Director General
Transport NSW
SYDNEY

ADDITIONAL SUBMISSION EIS ON CSELR

TRAMWAYS

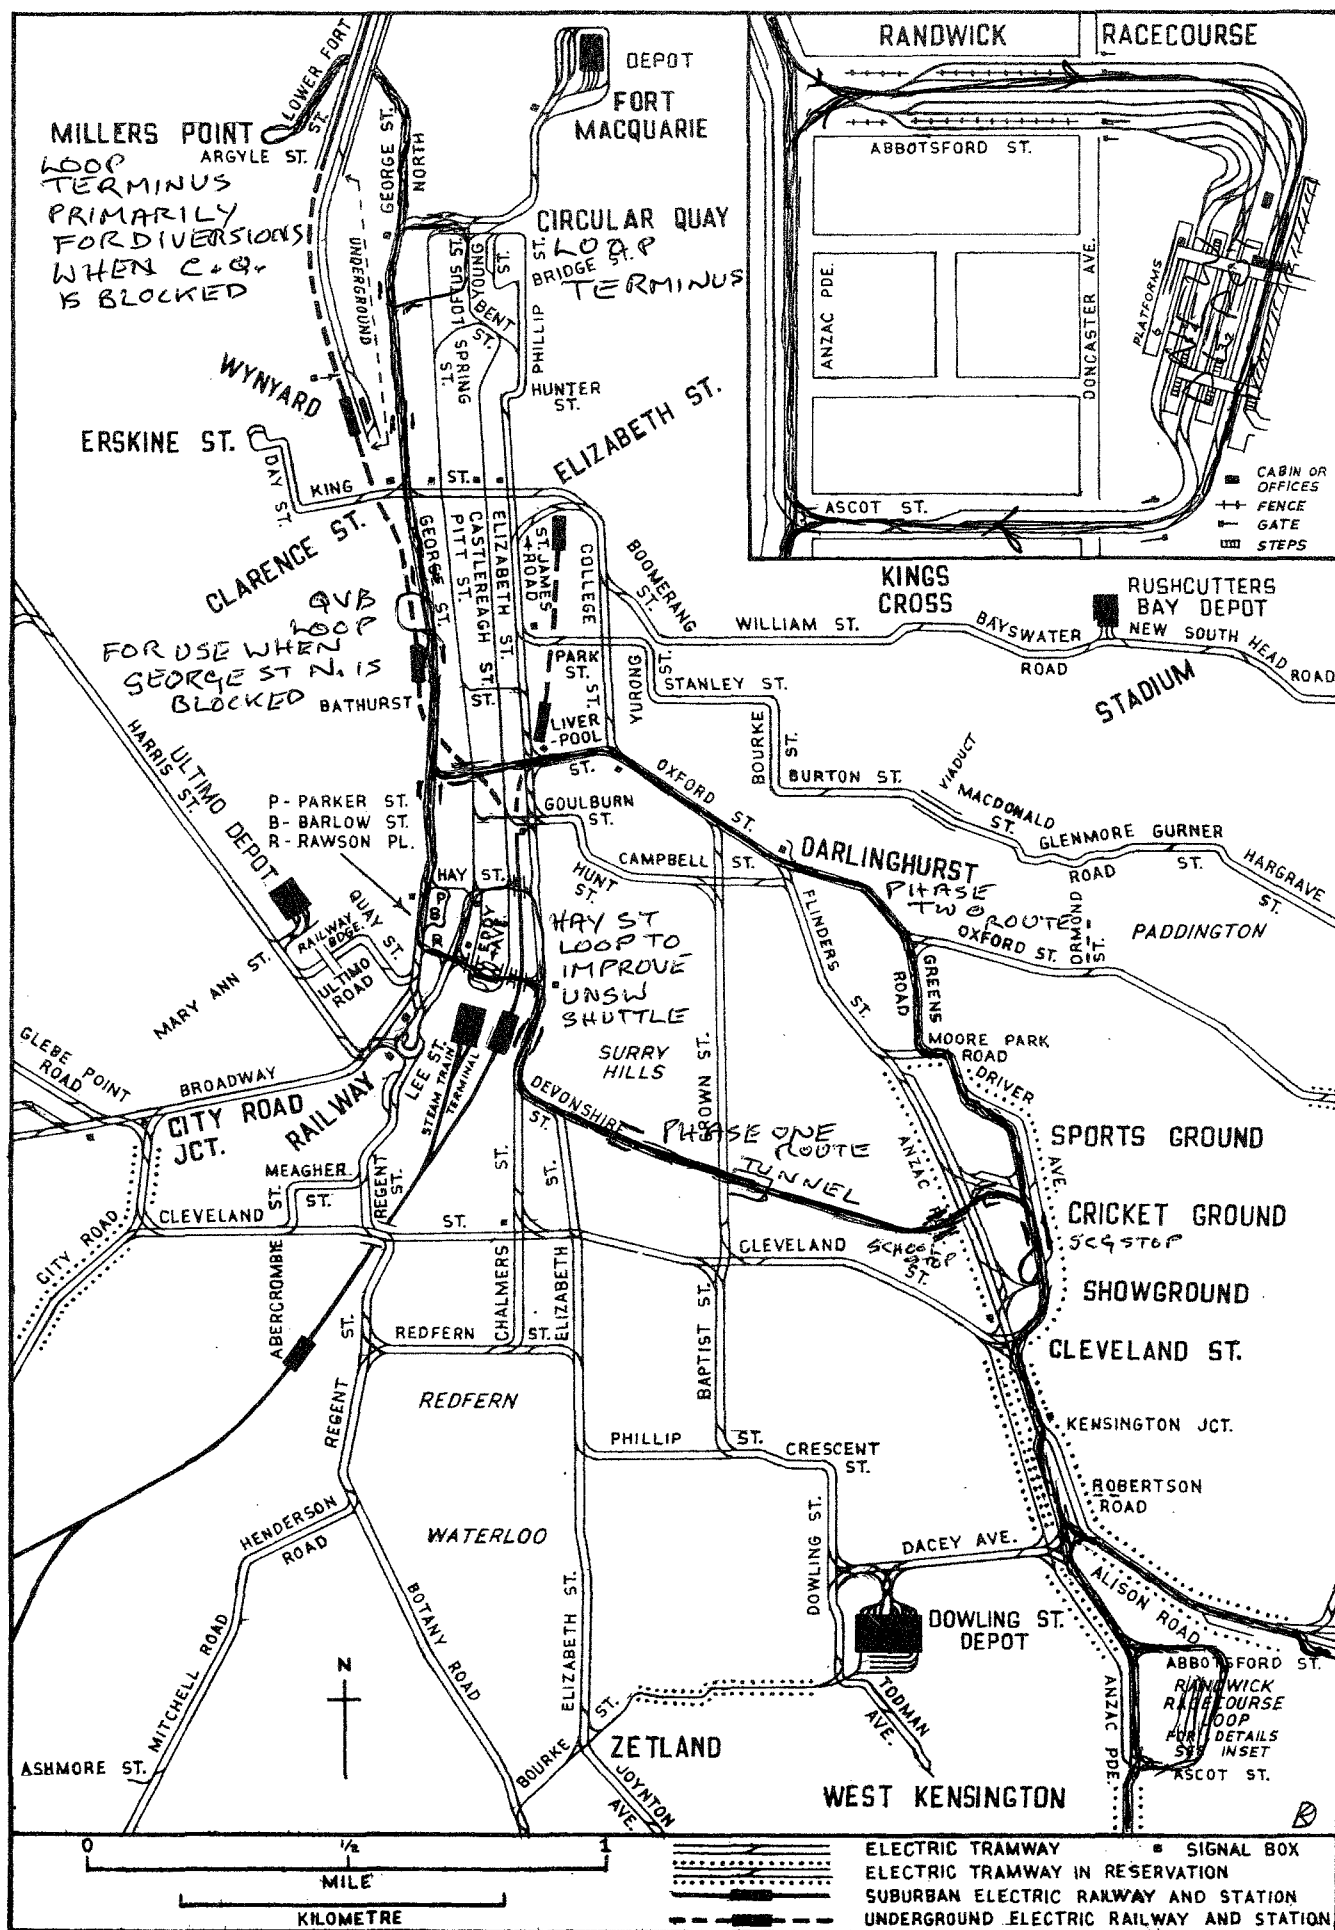
I enclose two drawings, based on maps from "The Tramways of Sydney" by David Keenan, showing my suggestions for the new light rail routes, including the suggested line via Diners Avenue, Greens

Road, Oxford Street and Liverpool Street as the additional route to access the northern CBD more quickly. They also show the proposed loop termini at Circular Quay via Loftus St and ~~Water~~ Bridge St, at Millers Point, primarily as a diversion route for times when Circular Quay is blocked by celebrations, etc, but also as a normal service (perhaps one in eight LRVs use this route), the Queen Victoria Building loop, for when George Street North is closed for parades, etc, a Hay Street loop, which would enable fast turnaround of LRVs for either a UNSW shuttle or Showground events shuttles, the loop at the Cricket Ground Stop, the Racecourse loop and stop, and the High Cross Park and Flemington Road loops at the outer termini.
